V-100
(2018)

FINAL PLAT FOR:
THE ARBORS AT
SEWELL MILL
16TH DISTRICT
LAND LOT 914
COBB COUNTY, GEORGIA

PETITION No.: V-100

TYPE OF VARIANCE: Waive the maximum height of a fence adjacent to a public road right-of-way and within
the required setback in a residential district from the required six (6) feet to eight (8) feet.

**FINAL PLAT FOR:
THE ARBORS AT SEWELL MILL
LAND LOT 914, 16TH DISTRICT
COBB COUNTY, GEORGIA
SPR-2012-0014B**

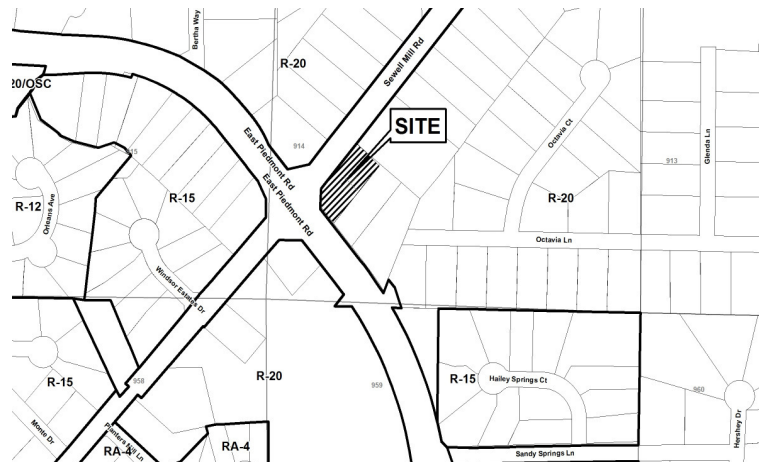
TRAFFIC: There are sight distance issues with the section of fence on Sewell Mill Road. Recommend the applicant submit a sight distance profile to Cobb County DOT upon redevelopment. If minimum sight distance requirements can not be met, recommend the applicant implement remedial measures, subject to the Department’s approval, to achieve the minimum sight distance requirement.

WATER: Fence appears to be in water main easement. If a wood privacy fence, it is “at-risk” per Code 122-155. If it is more substantial (footers, brick/masonry columns, etc.) it must be removed from easement.

SEWER: Fence appears to be in sewer main easement. Fence cannot block access to sewer manholes. If it is a wood privacy fence, it is “at-risk” per Code 122-155. If it is more substantial (footers, brick/masonry columns, etc.) it must be removed from easement.
